Title: Advisory Committee on Reactor Safeguards
 ESBWR Subcommittee: OPEN SESSION

Date: Wednesday, October 21, 2009

- GDCS Operation – During a LOCA
- GDCS Injection Line Configuration
- Inservice Testing GDCS Injection Lines
- Sources Non-Condensable Gases
- Alternate Calculations - GDCS Flow
- Summary

Sloping of Horizontal Runs

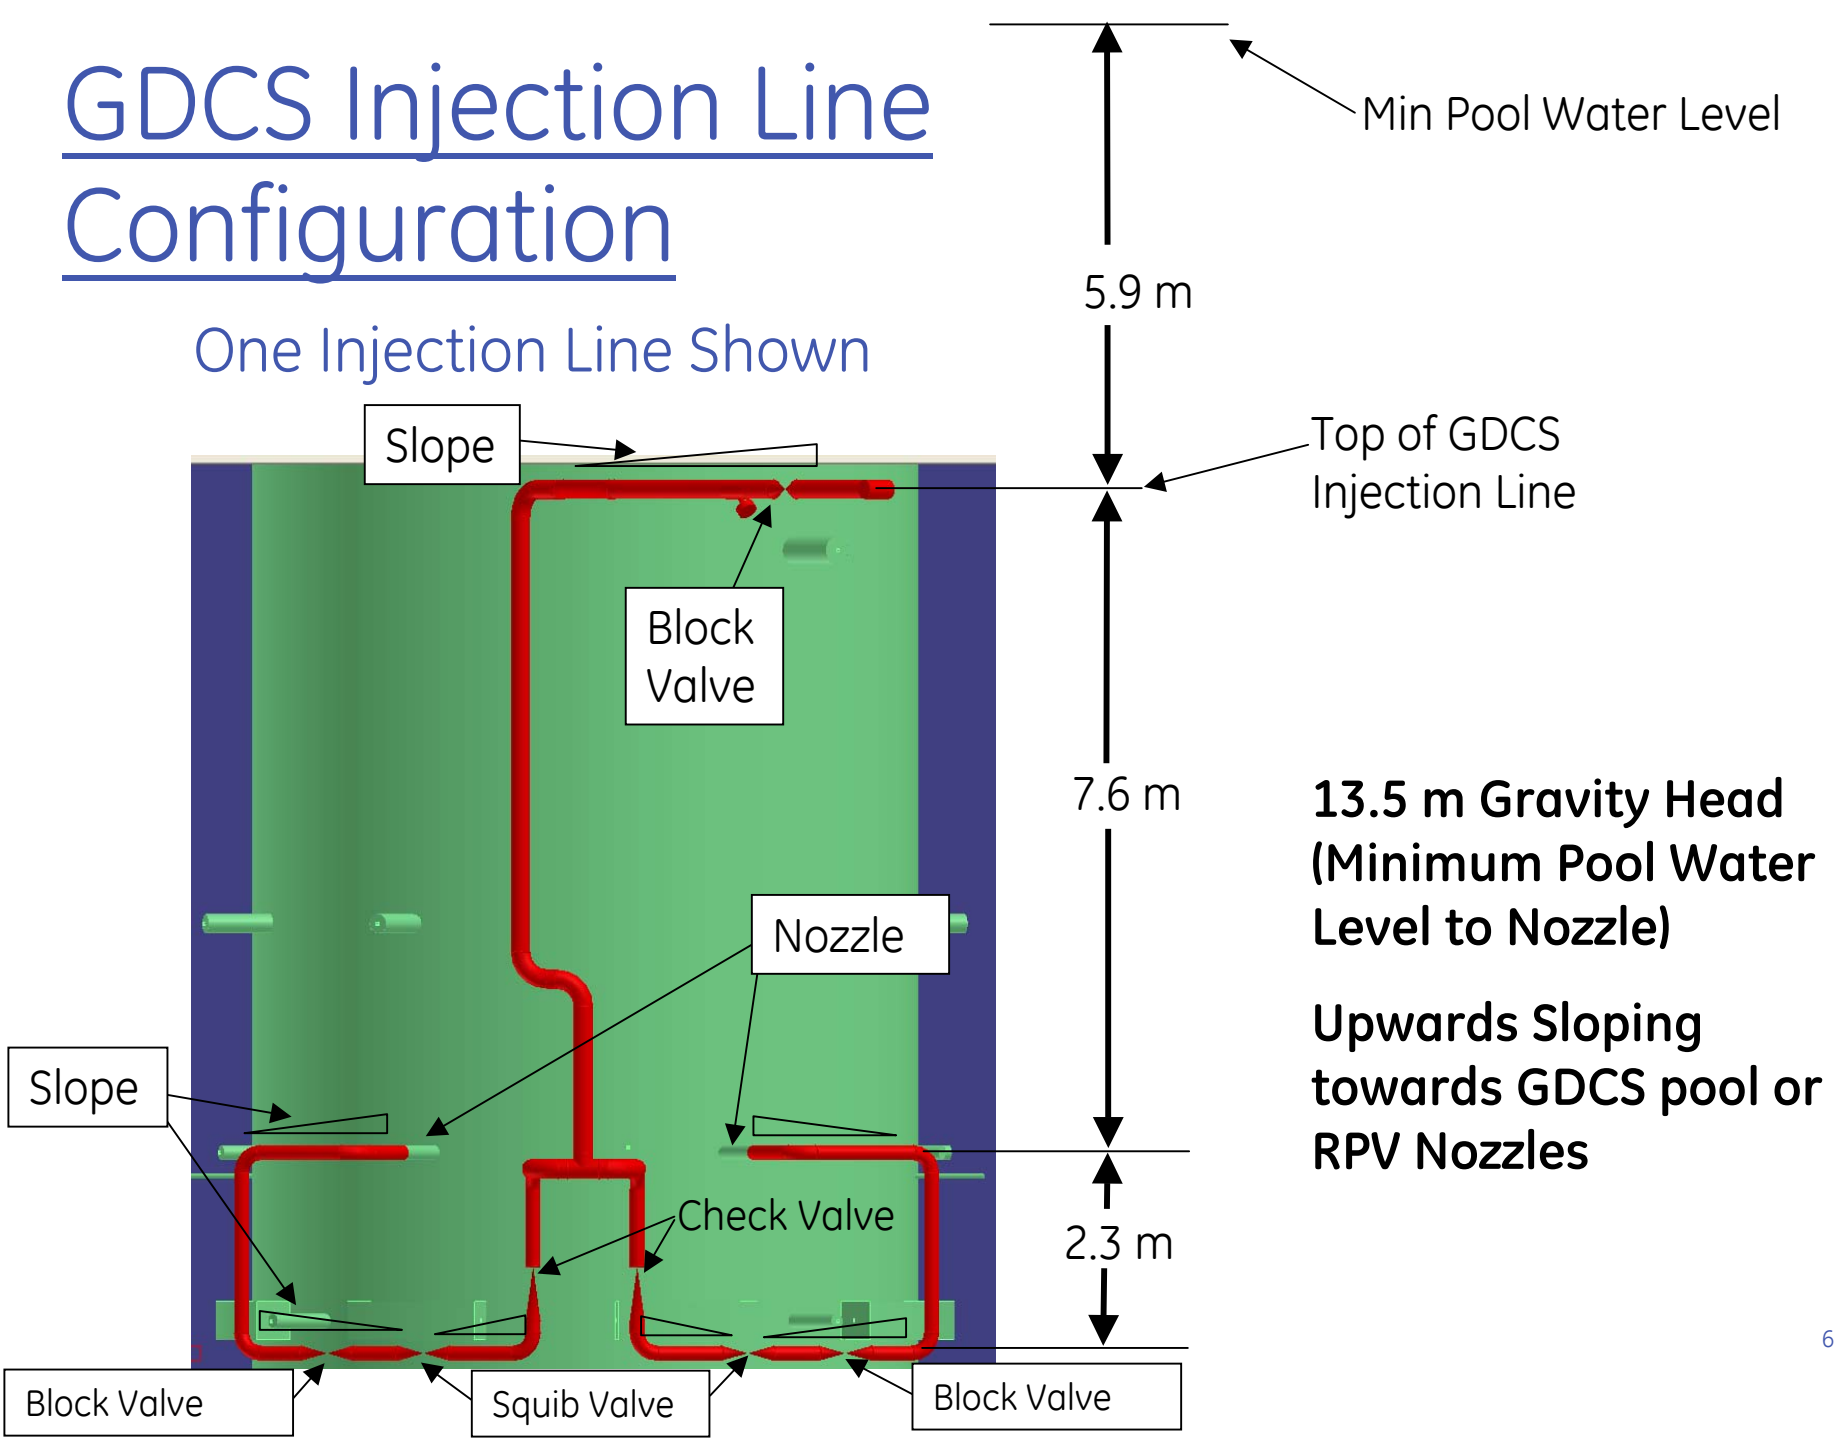
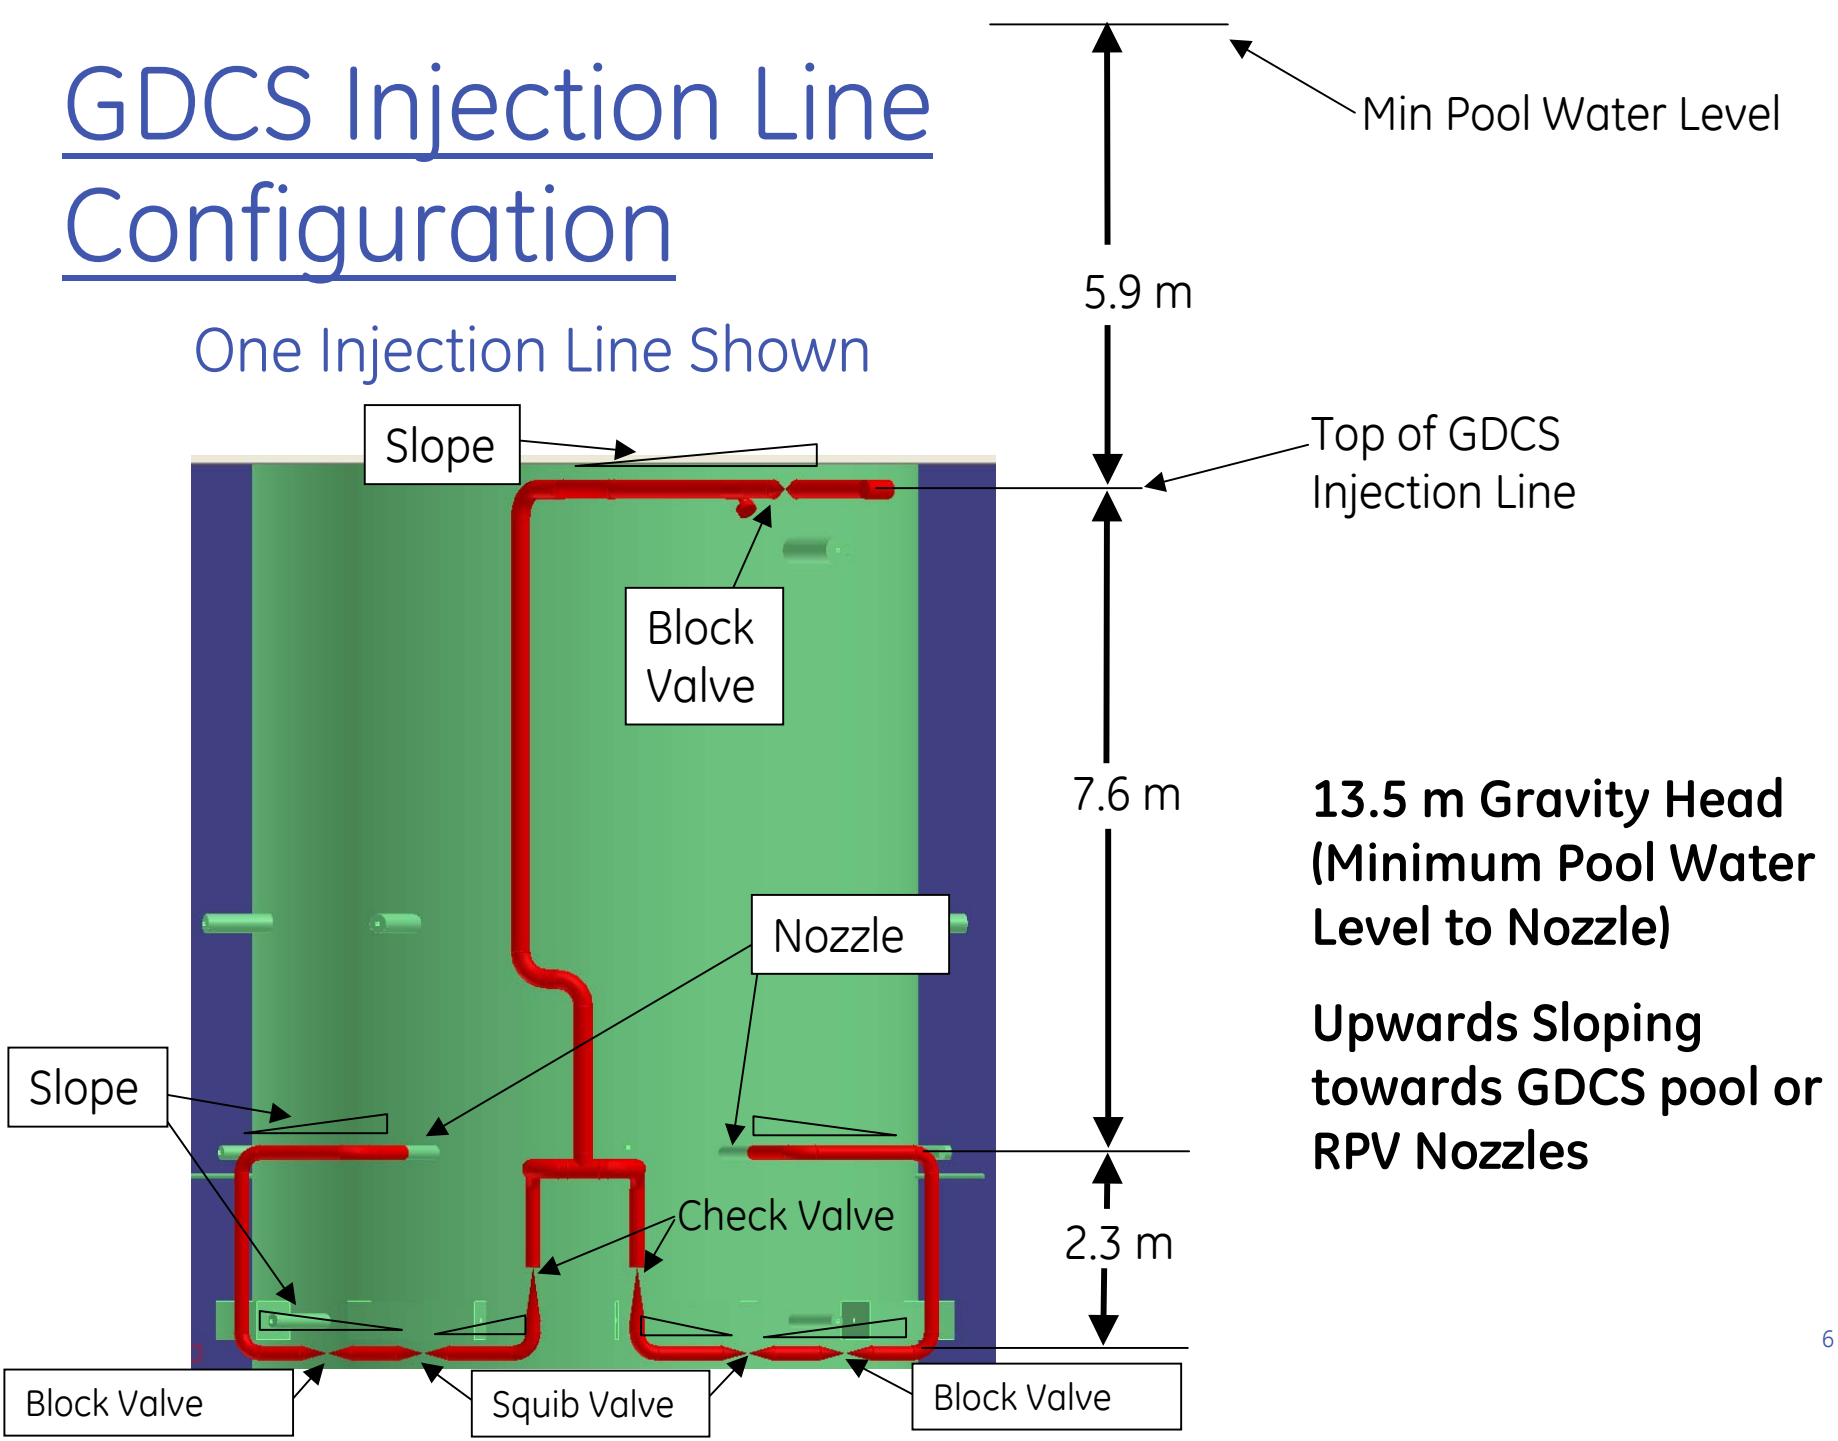
15 MEMBER BANERJEE: Can you go back to the
16 figure and show the sloping?

17 CONSULTANT WALLIS: It doesn't show that
18 in the figure. I don't think that is correct.

2 CONSULTANT WALLIS: If it is so big, you
3 should really show it on the figure, because it is
4 misleading to show it --

14 MEMBER BANERJEE: That is not shown in
15 the figure.

1 depiction, a 3D depiction, it is difficult to show
2 sloping, but the triangles here show the way. There's
3 the squib valve. Sloping is away from the squib
4 valve. So it is up. Of course, the vertical run, and
5 then, since this is downstream of the squib valve, you
6 have sloping up toward the nozzle.

19 MR. DIAZ-QUIROZ: No. No, it doesn't.
20 The figure doesn't show it.

16 MR. DIAZ-QUIROZ: No, it's not. That
17 detail is not shown in the figure, you're right.

- Upstream of Squib Valve – Sloped Upwards Towards GDCS Pools
- Downstream of Squib Valve – Sloped Upwards Towards RPV Nozzles

Introduction

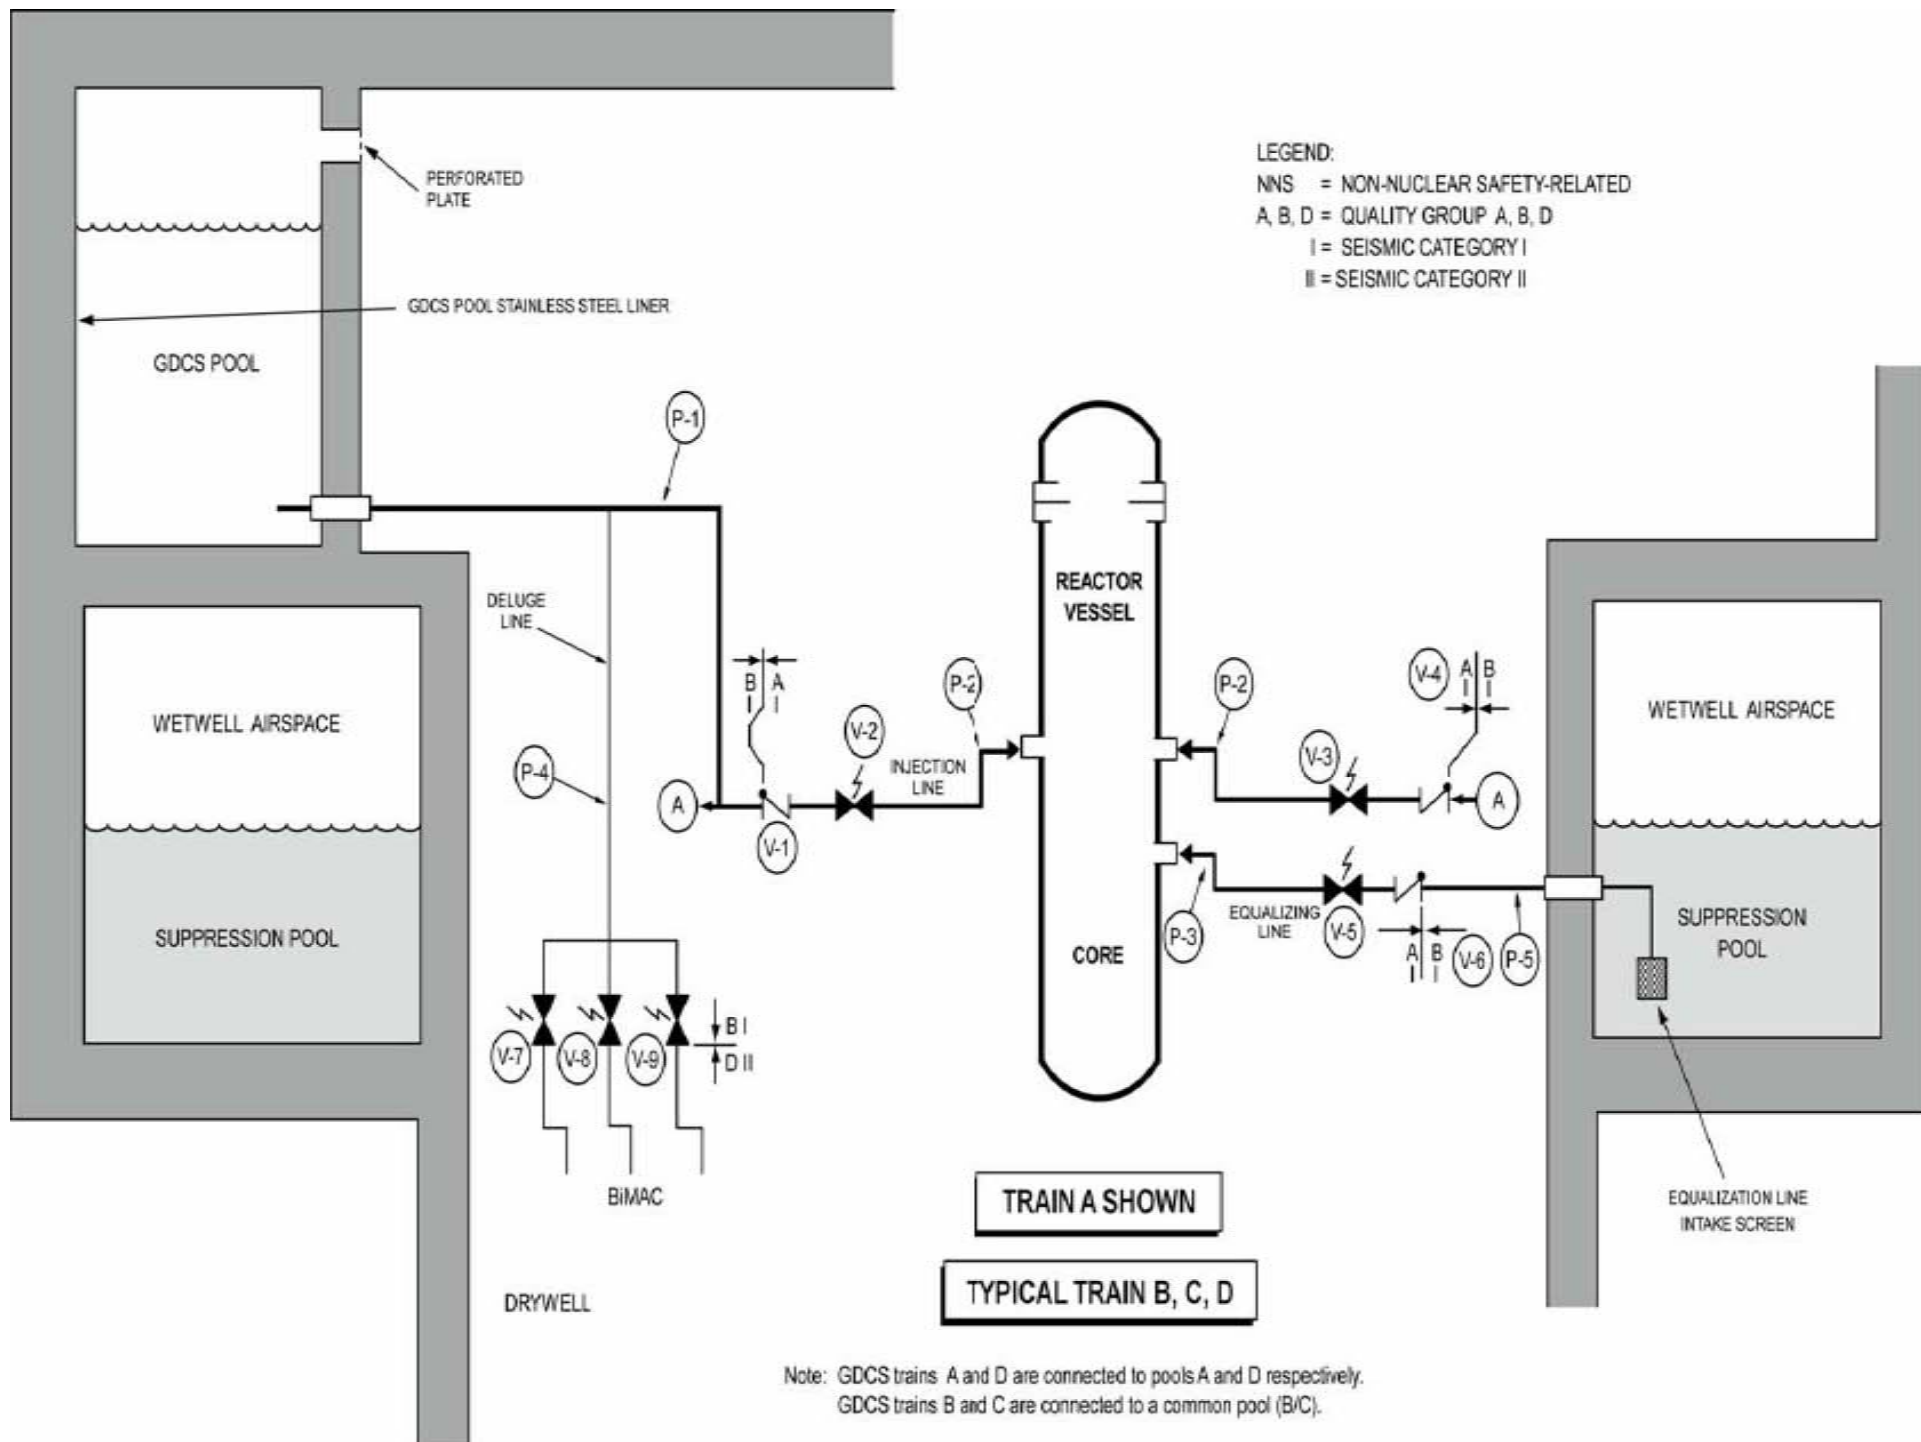
16 CONSULTANT WALLIS: This is another one of
17 these cases where the cartoon is very misleading. It
18 doesn't show the sloping-up of the lines.

2 MR. SCARBROUGH: Yes, these are, in fact,
3 the drawings that are in the tier one. They are just
4 sort of conceptual. But you're right, that's why, in
5 terms of we did ask for an RAI and received an
6 isometric drawing of it to get a better feel for it,
7 but you're exactly right, these are not clear.
